SCHEDULE OF ALTERATIONS PROPOSED

PROJECT 11 PRIMROSE HILL ROAD

LONDON NW3 3DG

SCHEDULE OF PROPOSALS

SECTION A-A APPROVED UNDER PP. 2016/3956/P

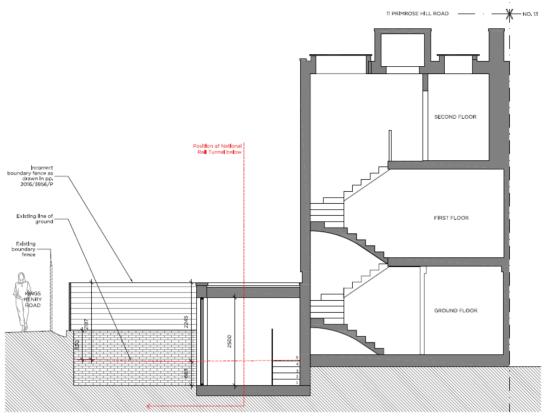
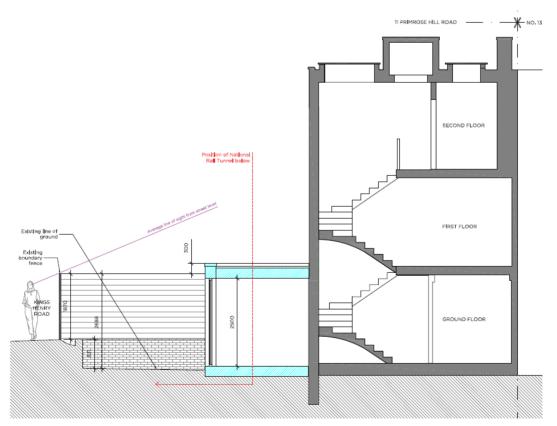
The amendment seeks to alter the height of the side extension, in order to minimise digging as much as possible, since the presence of a National Rail tunnel just below the garden/extension perimeter.

Furthermore, with this application, we would like to rectify the height and location of the existing boundary fence that was incorrectly drawn on the section drawing of the planning permission 2016/3956/P.

PROPOSED SECTION A-A
